RE: Christina Court Development - Plan Commission Application -- Round 1 Responses

Please find the enclosed revised engineering plans and comments in response the comments received on March 3, 2015 from the Village of Arlington Heights in connection with the Christina Court Plan Commission Application located at 1306 & 1310 E. Olive Street in the Village of Arlington Heights, IL.

Olive St Front Yard Setbacks

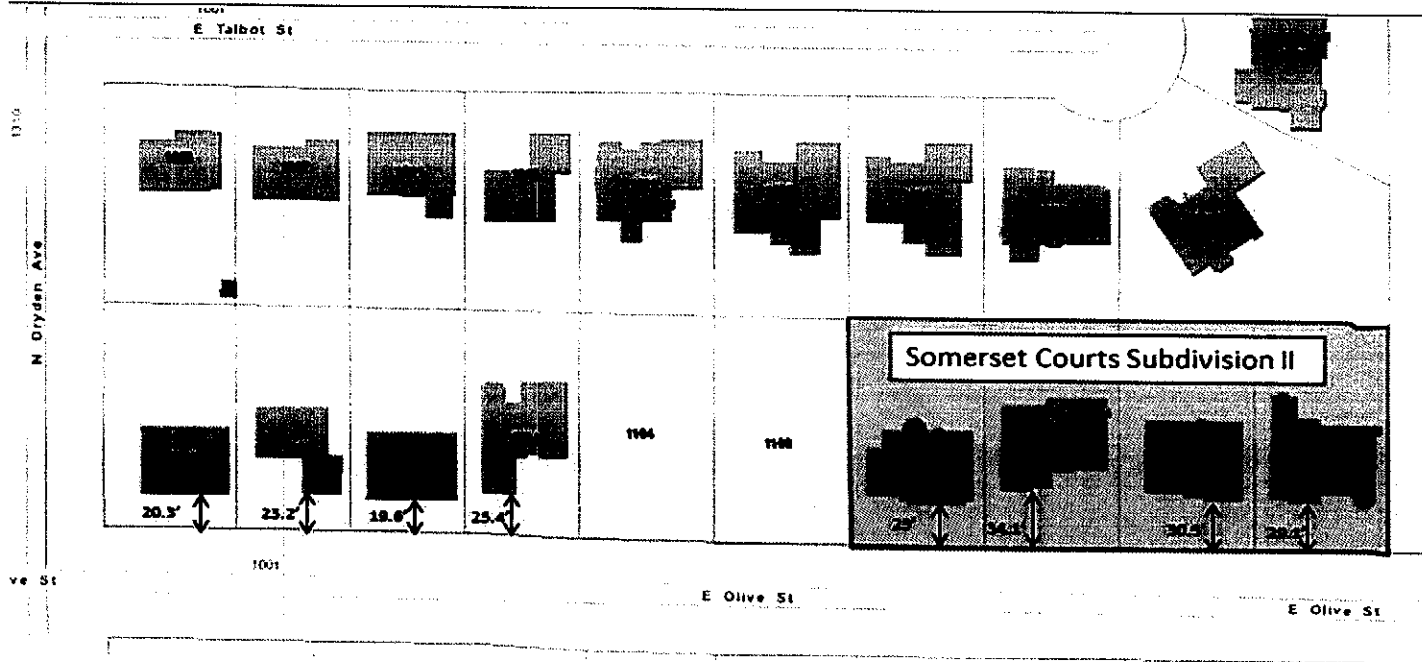
9. For Lot 1, the side along Olive Street is considered the exterior side. Per Chapter 28, in all residential districts, where lots comprising 40% or more of the frontage between two intersecting streets are developed with buildings having a yard of more than 10 feet in depth adjacent to the street, the average of such yards shall establish the minimum exterior side yard for the entire frontage. A minimum exterior side yard of 10% of the lot width with a minimum of 10 feet, shall be required for all lots. In no case shall an exterior side yard of more than 40 feet be required. Therefore Lot 1, the exterior yard along Olive Street shall be the average of the yards between Williams Way and Dryden Avenue. *Lot 1 will meet the minimum side yard setback as required per Chapter 28 requirements. Please see the attached Exhibit that illustrates the sideyard setback for Lot 1 will exceed the requirement as required per Chapter 28 requirements.*

Christina Court Lot 1	
Sideyard Setback	25
